CRAIGIEBUCKLER AND SEAFIELD COMMUNITY COUNCIL

Planning Officer's Report

01 September 2020

Application Number: 200659/DPP. Type: Detailed Planning Permission: Land at Countesswells Road Aberdeen. Proposal: Erection of Class 1 (shops) retail unit with associated car parking, access, landscaping and associated works Applicant: Aldi Stores Ltd., Pottishaw Road, Bathgate, EH48 2FB.

Proposed Site Plan

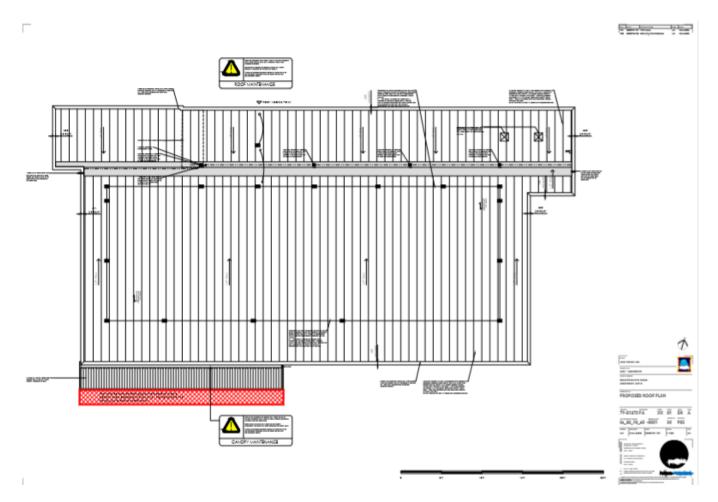
It is noted that the application proposes the formation of a car park and associated access. The intense light emitted by the headlights of cars entering or leaving the carpark could adversely impact upon the amenities and the nearby properties in Pinewood Gardens.

The houses most likely affected in Pinewood Gardens are close to the perimeter of the planned carpark. We also contend that other properties in Pinewood Gardens will be similarly affected.

The level of illumination for the carpark (15 - 20 lux) will, in our opinion, tend to intrude on neighbouring private residences. For example, homes in Pinewood Gardens may well have light from the carpark shining on their upper storeys.

The noise from traffic (including the delivery vehicles) entering and leaving the carpark is likely, in our opinion, to disturb the residents of nearby homes.
